Access Compliance Report

Public Rights-of-Way

(Curb Ramps)

Intersection ID: 9951	Main Street: S_TURNER_AV	Cross Street: W_TRADE_ST	Location: W
ADA ID: C5D51E44179D	Ramp Type: Perp	Initial Pass/Fail: Fail	Overall Compliance: No
Severity Score: 22.5			
Codes/Mitigation Info/Possible Solution		Field Measurements/Component Compliance

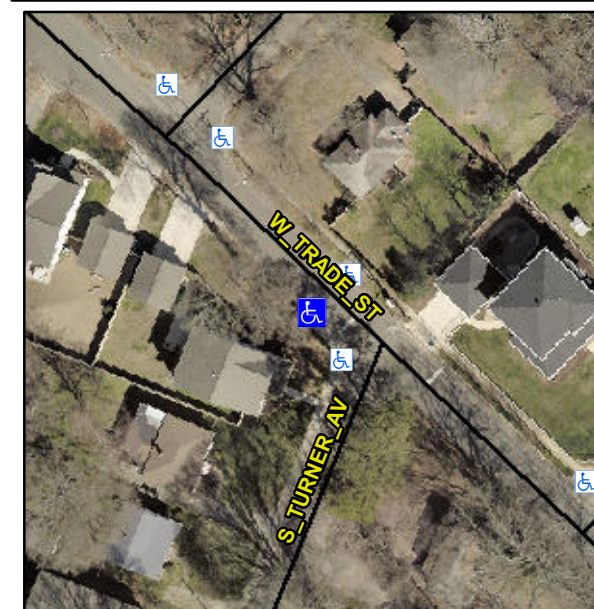
Not Found, R304.5.1, R304.2.2, R304.5.3

Compliance	Description	Data	Compliance	Description	Data
N/A	Ramp Length (in)	60.0	No	Ramp Slope (%)	10.0
No	Ramp Width (in)	47.0	No	Ramp XSlope (%)	3.6
N/A	Flare Type LT	N/A	N/A	Flare Type RT	N/A
N/A	Flare Slope LT (%)	N/A	N/A	Flare Slope RT (%)	N/A
N/A	Flare Traversable LT?	N/A	N/A	Flare Traversable RT?	N/A
N/A	Landing Length (in)	N/A	N/A	DWS Provided?	N/A
N/A	Landing Width (in)	N/A	N/A	DWS Contrast?	N/A
N/A	Landing Slope (%)	N/A	N/A	DWS Length (in)	N/A
N/A	Landing X Slope (%)	N/A	N/A	DWS Full Width?	N/A
N/A	Landing Curb? (Y/N)	N/A	N/A	DWS Offset (in)	N/A
N/A	Shared Landing?	N/A			
N/A	Gutter Ponding?	N/A	N/A	Gutter Slope (%)	N/A
N/A	Gutter Lip Ht (in)	N/A	N/A	Gutter X Slope (%)	N/A
N/A	Painted X Walk1?	No	N/A	Painted X Walk2?	N/A
	X Walk 1 Direction	To NE		X Walk 2 Direction	N/A
N/A	X Walk 1 Width (in)	N/A	N/A	X Walk 2 Width (in)	N/A
	X Walk 1 Slope (%)	1.1		X Walk 2 Slope (%)	N/A
	X Walk 1 X Slope (%)	3.9		X Walk 2 X Slope (%)	N/A

Remove & Replace Entire Ramp.
